City of Mississauga Department Comments

Date Finalized: 2021-11-24	File(s): A539.21 Ward 6
To: Committee of Adjustment	
From: Committee of Adjustment Coordinator	Meeting date:2021-12-02 1:00:00 PM

The applicant requests the Committee to approve a minor variance to allow an existing widened driveway with:

Property Address: 5711 Riverdale Creacent

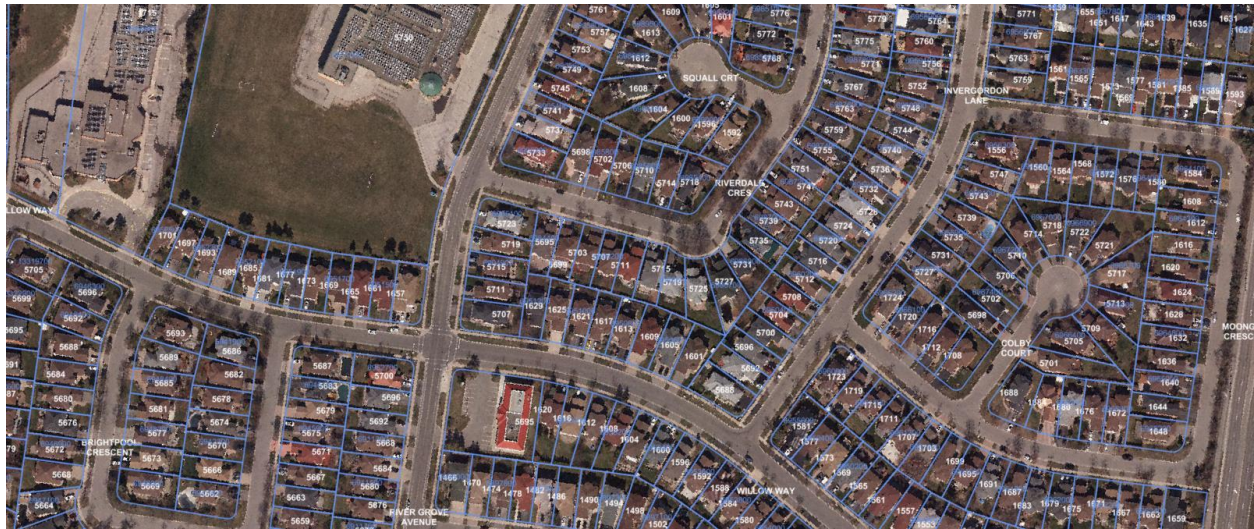
Enclosed for Committee's information are some photos of the existing driveway. This department notes that with regard to the widened driveway within the municipal boulevard (the area between the municipal curb and property line) we would request that this area be reinstated with topsoil and sod should the application be modified to reflect a smaller driveway width within the subject property or if the application is not supported by the Committee.

With regards to variance #2 requesting a 0.0m setback to the lot line, when reviewing these types of variances for increased hard surfaces being proposed where grassy permeable surfaces exist or existed, we are concerned with the additional hard surface treatment as this essentially increases the flow of water into the municipal storm sewer system. Incremental increases across the neighbourhood and the city essentially can have increased pressure on the City's storm sewer system. Lots are designed to typically retain some rain water through infiltration of water into the permeable surfaces such as grass. The by-law requirement of a 0.60m setback to the driveway maintains a permeable grassed swale that will allow infiltration of water as it runs towards the street.

In view of the above we cannot support the request to have a reduced 0.0m setback to the lot line.
